## ODOT PROJECT 190108

### REBAR CLEARANCE ISSUE – 0029L

#### DRB ADVISORY OPINION AMENDED DOCUMENTATION

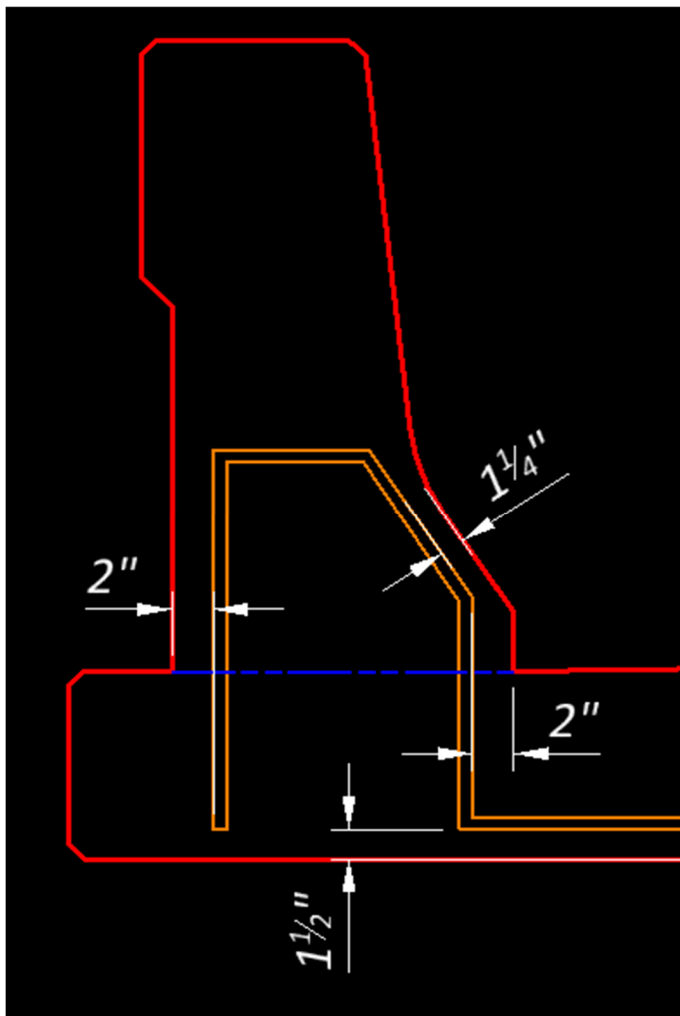
KCC Position – In our opinion, the recent discovery of additional detailing errors associated with the S5149 bars completely explains what KCC and ODOT witnessed in the field. Our position has always been that when contractual tolerances are considered, the thin coverage over bar S5149 could be explained. The new information demonstrates that prior to applying any of the contractual tolerances for placement and construction we started with 1.25" of coverage over the S5149 bars. See detail below.

The fact that the coverage was documented as +/- 1" for the duration of the wall confirms that KCC crews were very consistent in the slipforming of the railing and well within the contractual tolerances allowed in C&MS 509 & 511.
